22-003-SE

Special Exception Staff Report

Applicant | CitySwitch II-A, LLC

Address | 1117 NW 9th Street

COMPOUND PLAN

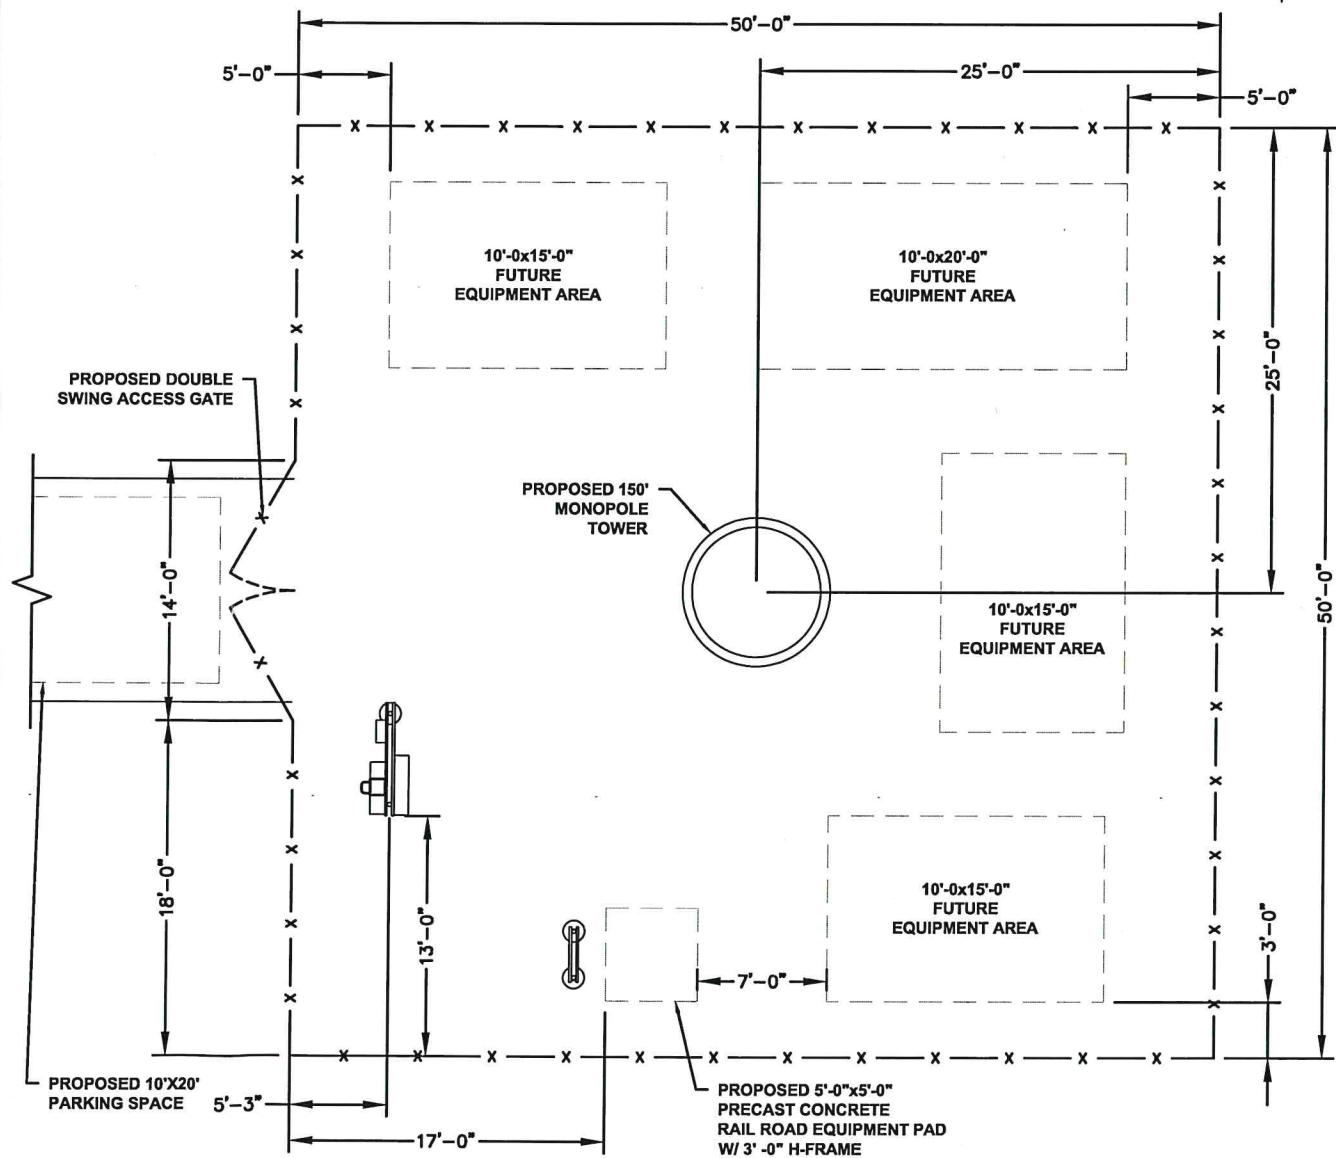
Staff Comments: The submitted plans depict perimeter fencing surrounded by landscape screening in compliance with City LDC 90-603(f) and LDC 90-603(g).

FENCING DETAIL

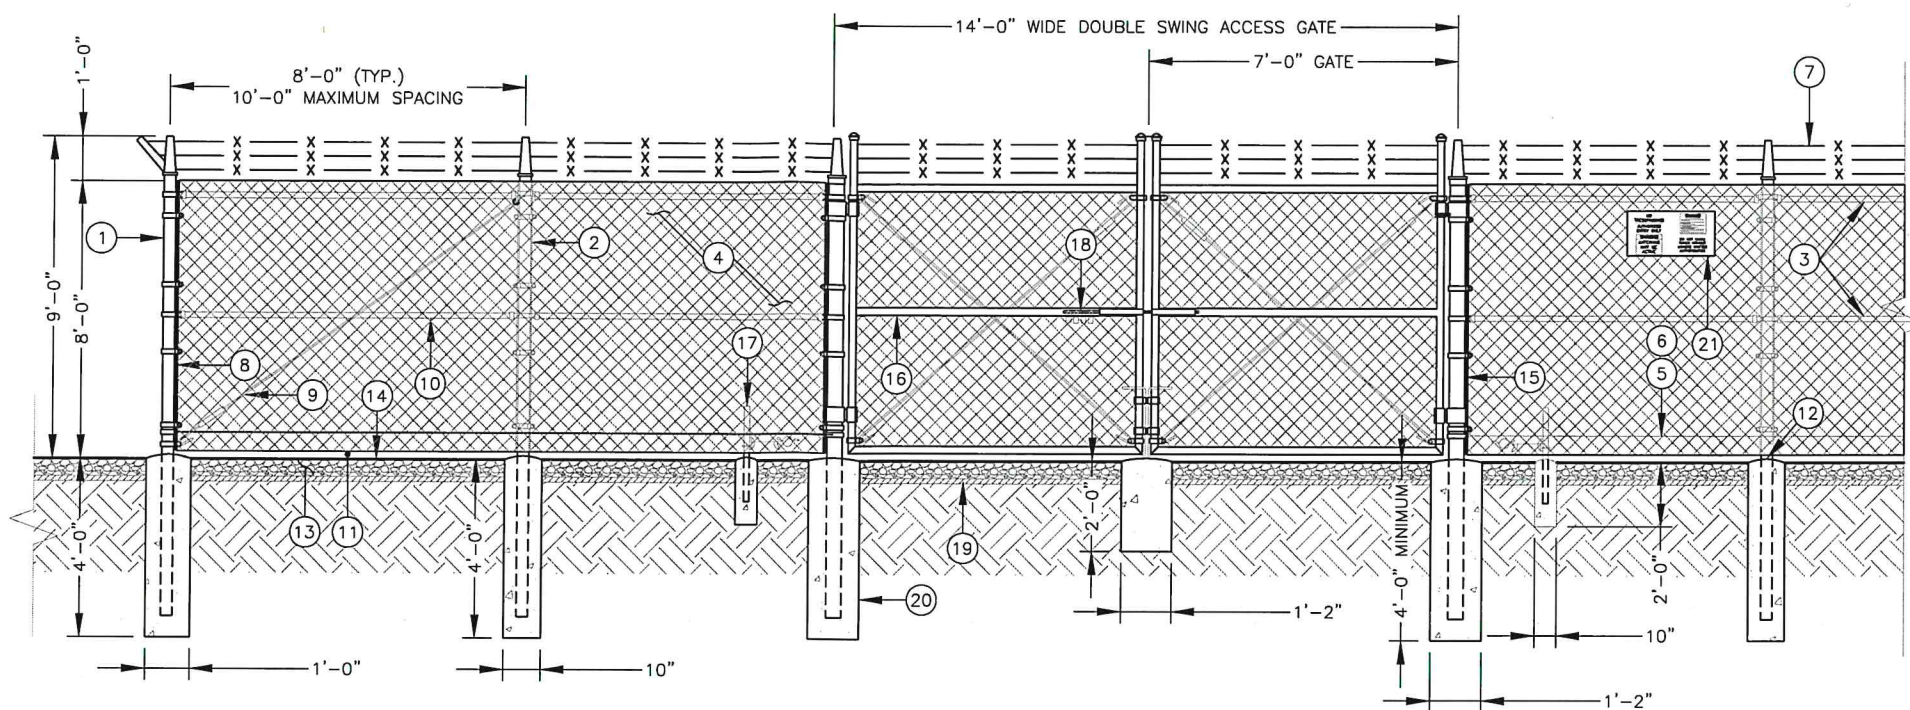
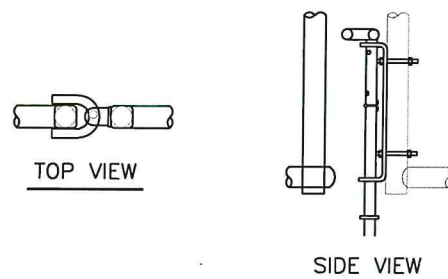
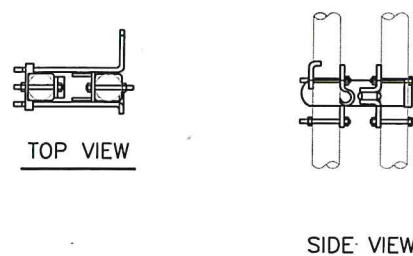
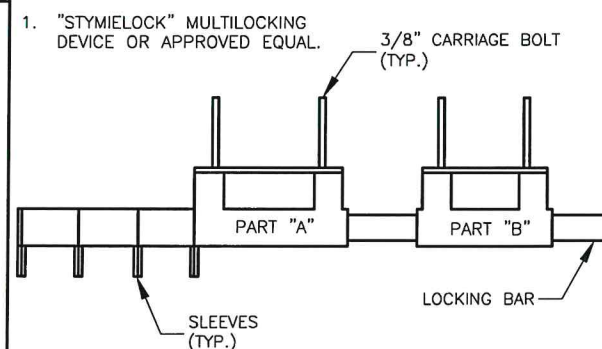
Plans depict fencing in compliance with City LDC 90-603. However, total fence height exceeds 8 feet, which does not comply with City LDC 90-639. Plans shall be revised to provide total fence height of exactly 8 feet.

2. Plans shall be revised to provide total perimeter fence height of exactly 8 feet.
3. Submittal of FAA approval for proposed tower design/height.
4. The use of any portion of a tower for sign or advertising purposes including, without limitation, company name, banner, or streamer is prohibited.
